SERVICE BULLETIN No 10-21

**PRODUCTION CHANGE**

**SUBJECT: ENGINE DAMPNER SECURING BOLT**  
**VEHICLES: ALL**

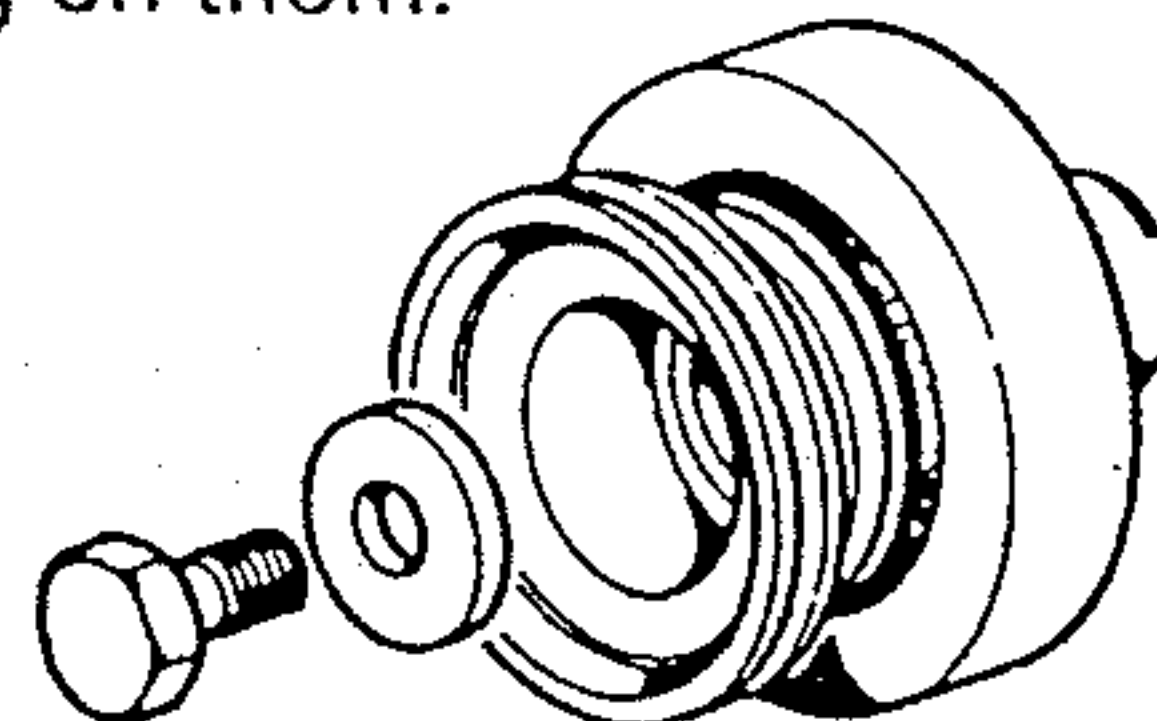
The bolt securing the front dampner is installed with loctite type 242; the torque specification remains unchanged (20 Kgm = 145 ft. lb.). The bolts installed with this new procedure can be recognized from a yellow painted marking on them.
